UNITED STATES
DEPARTMENT OF THE INTERIOR
BUREAU OF LAND MANAGEMENT

OCD Artesia
EMNRD-OCD ARTESIAFORM APPROVED
OMB NO. 1004-0137
Expires: January 31, 2018**SUNDRY NOTICES AND REPORTS ON WELLS**
Do not use this form for proposals to drill or to re-enter an abandoned well. Use form 3160-3 (APD) for such proposals.5. Lease Serial No.
NMNM029301

☐ Oil Well ☒ Gas Well ☐ Other8. Well Name and No.
MARTHA CREEK GAS COM 6

Permanent Abandonment of Federal Wells
Conditions of Approval

OXY USA WTP LP - Proposed
Martha Creek Gas Com #6Q
API No. 30-015-32165

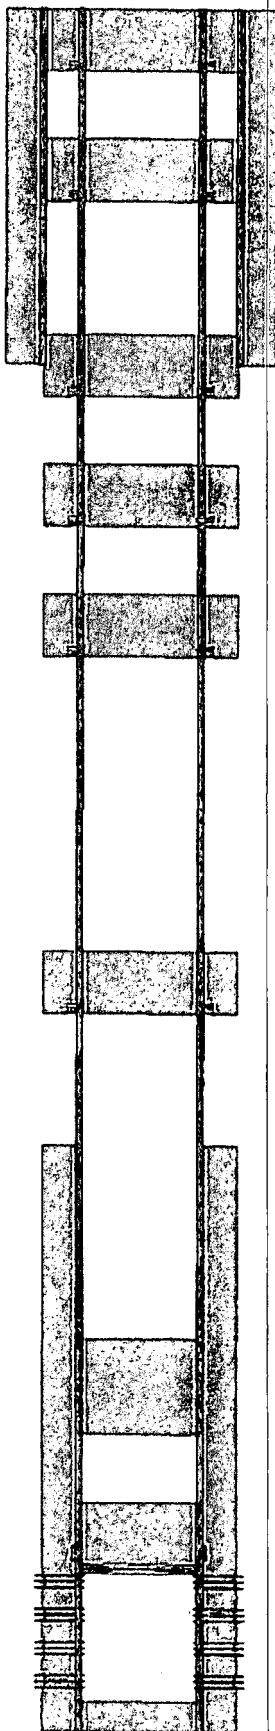
GC 1/20/20
Accepted for record - NMOCD

7380 - 7210

**SEE ATTACHED FOR
CONDITIONS OF APPROVAL**
